**DOCKET ITEM #3**  
**Development Site Plan #2016-0018**  
**Transportation Management Plan SUP #2016-0039**  
**5001 Eisenhower Avenue – Victory Center Amendment**

Purpose of Application
The applicant is proposing to amend this property's preliminary development site plan (DSP2014-0030) to include one office building/conference center, one above-ground parking garage and up to 14,000 sq. ft. of retail.
Special Use Permits and Modifications Requested:
None

**Development Site Plan #2016-0018  
Transportation Management Plan  
SUP #2016-0039  
5001 Eisenhower Avenue - Victory Center**

Figure 3b – Alternate B: Modified Applicant Plan

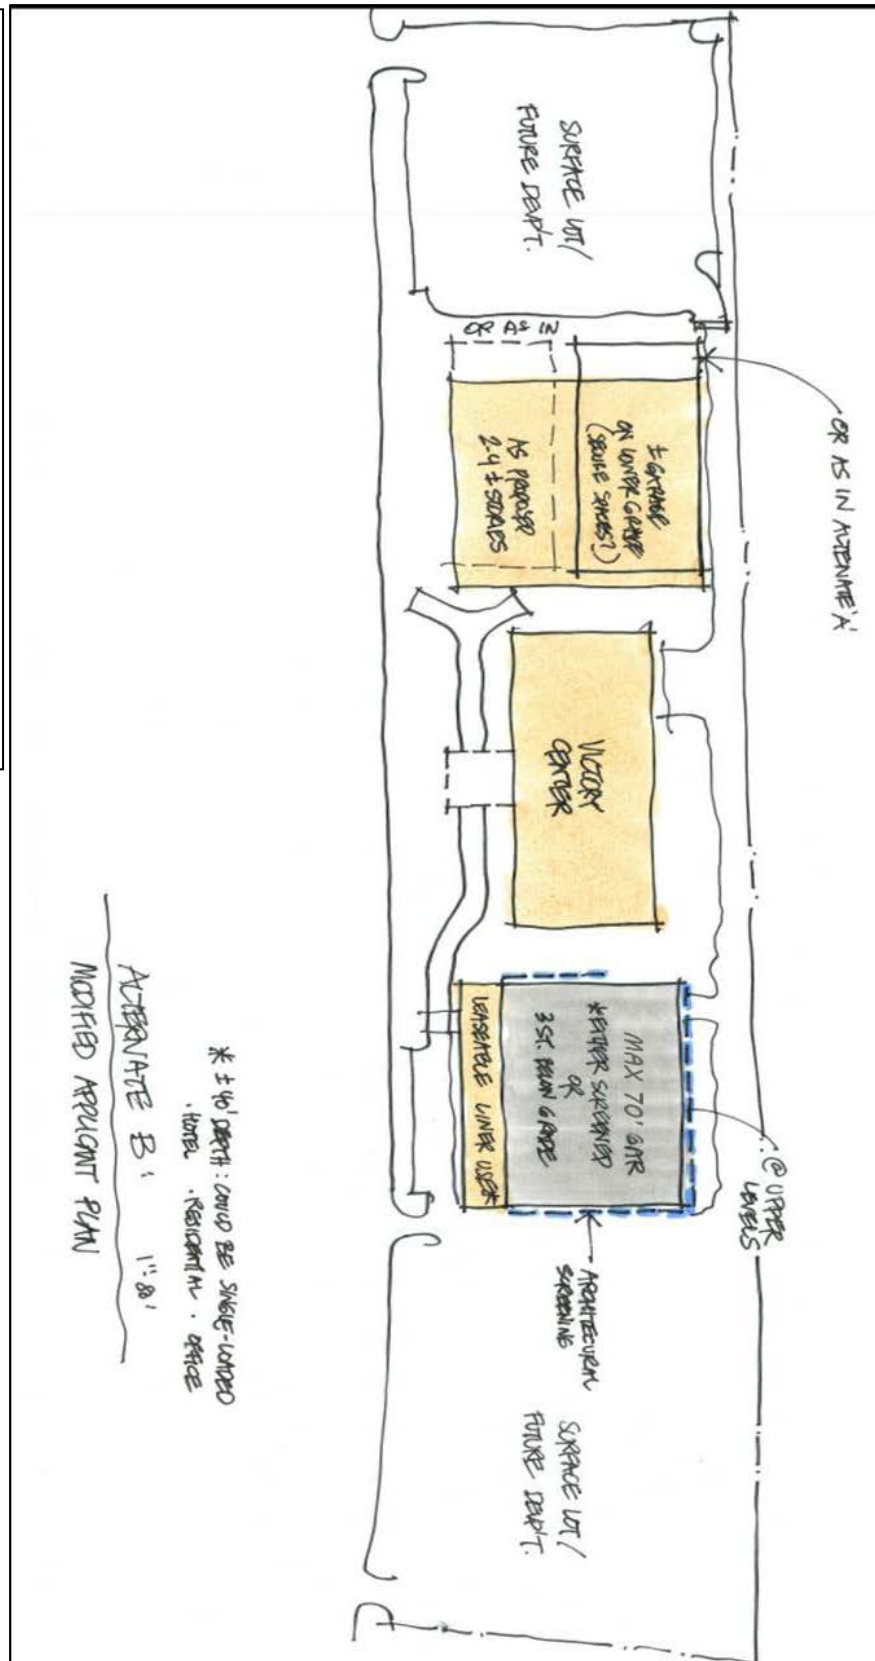
The Plan calls for active uses to be located on all street frontages, which is not feasible given the security requirements of the Federal tenants being sought. Previous approvals have always called for, and allowed, above ground parking structures at this site. DSP#2004-0037 allowed up to three parking structures; DSP#2010-0011 allowed two structures at 62' each. The current proposal has one structure, which will be limited to maximum height of 70'. Staff has also provided alternative building proposals, that would also help to minimize these effects, as shown in the graphics (Figures 3a and 3b) at the end of the report, and discussed in the staff analysis.

With this request, the applicant is asking for an additional 4,000 square feet of retail, and for the 14,000 square feet to be located at the front of the parking garage, with a street-facing row of 19 convenience parking spaces. They are also requesting two new curbcuts to be located on the eastern side of the office building, in front of the parking structure to provide circular pick-up and drop-off access for the retail.

The Eisenhower West Small Area Plan discusses at length the goals and vision for Eisenhower Avenue to become a Great Street, with active uses fronting the sidewalks. Staff's initial recommendation for the retail was to bring it to the back of sidewalk, which would activate the sidewalk and better screen the parking garage. The applicant noted that there were two issues with this request. The first was that, given the location of the EVE, and the need for direct access to the front of the existing building in the event of an emergency, the drive aisle needed to remain in its proposed location. Additionally, the

8. **CONDITION ADDED BY STAFF:** The retail parking spaces located directly south of the proposed retail space shall be phased for removal once development is approved on the portion of the lot east of the proposed parking garage. The retail parking and drive aisle shall be converted into a plaza area with an EVE, to better conform to the Eisenhower West Small Area Plan design guidelines. This development shall accommodate those spaces or obtain approval of a parking reduction. (P&Z)(T&ES)

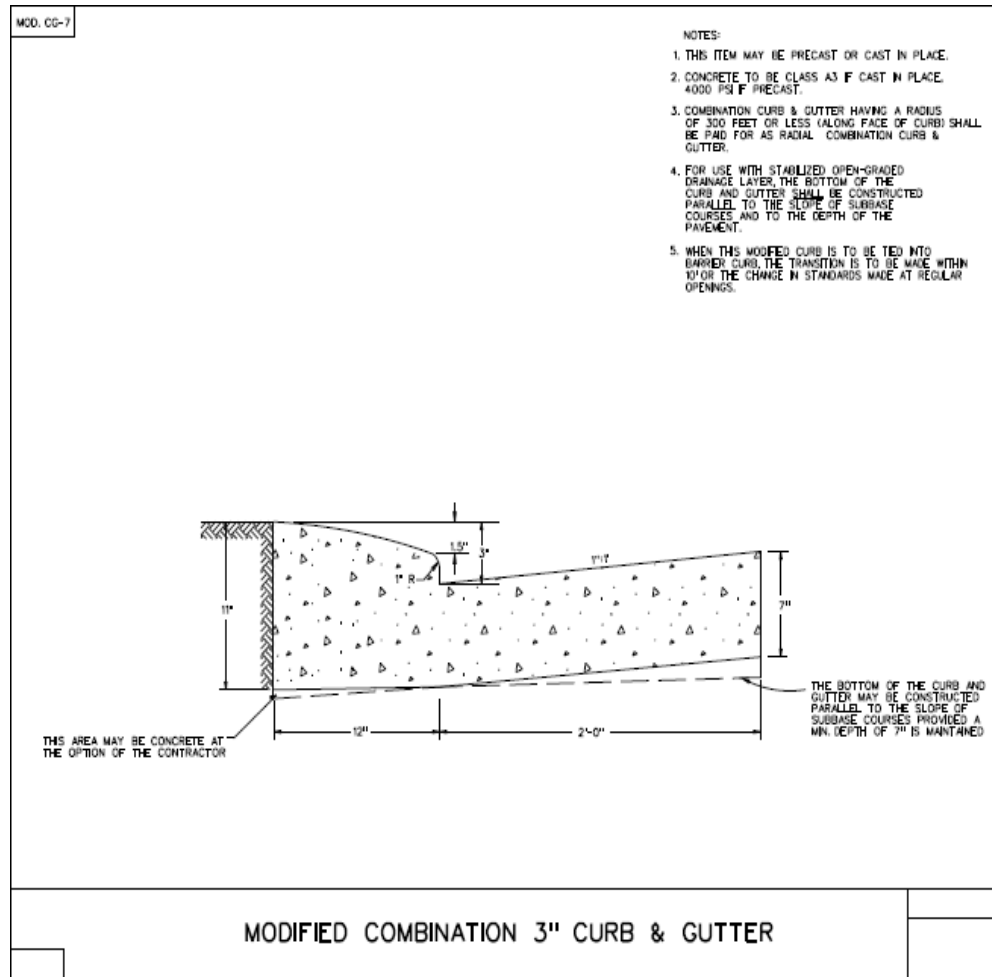
C-7 **CODE REQUIREMENT ADDED BY STAFF** The fire service plan shall show placement of emergency vehicle easement signs. See sign detail and placement requirements are as follows:

Emergency vehicle easements shall be a minimum of 22 feet across the travel lane. The emergency vehicle easement shall provide access to strategic areas of the building and fire protection systems. Curbing and street components shall

Tower 203 Turning Specifications

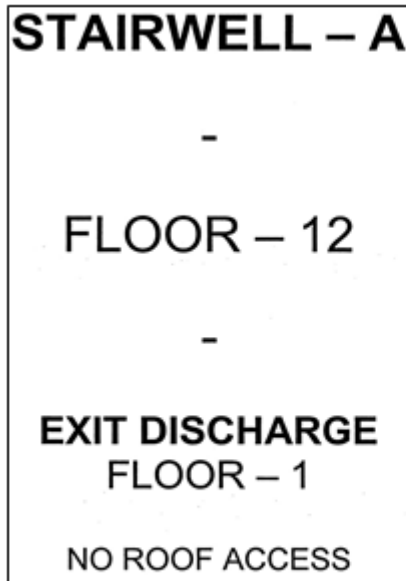
C-8 **CODE REQUIREMENT ADDED BY STAFF** Show fire apparatus vehicle turning radius for all roadways based on the following specifications:

- Turning Radius – Wall to Wall = 54.98 feet + / - 2 feet
- Curb to Curb = 51.33 feet + / - 2 feet
- Inside turning radius = 37.73 feet + / - 2 feet
- Overall Length – 47' – 4 ½"
- Overall Width – 98"
- Wheel Bases from front axle to both rear axles – 240"
- Tandem axle spacing – 56" CL of axle to CL of axle
- Gross Weight – As built with no equipment or water gross weight = 66,000 lbs
- Angle of Approach – 13 Degrees
- Angle of Departure – 11 degrees
- Ramp Break Over – Break over angle is 9°

Ex. Stairway Identification Sign

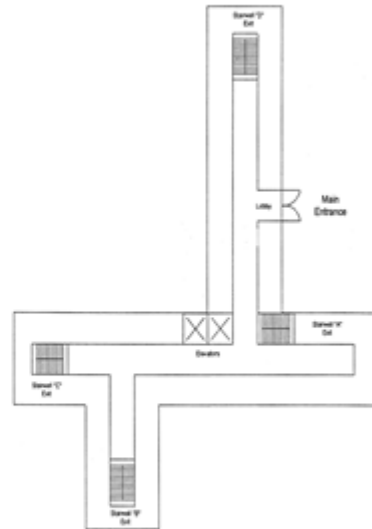
C-9 **CODE REQUIREMENT ADDED BY STAFF** Provide Stairway Identification. Stairway identification signs shall be provided at each landing in all interior exit stairways connecting more than three stories. Stairways shall be identified by letter designation starting next to the main entrance with "A" and continuing in a clockwise or left to right pattern using consecutive letters of the alphabet for each additional stairway. Two copies of the stairway signs shall be submitted to the fire official for approval before occupancy.

exterior and the general layout of the lobby of the first floor. Stairways shall be denoted by letter as required.
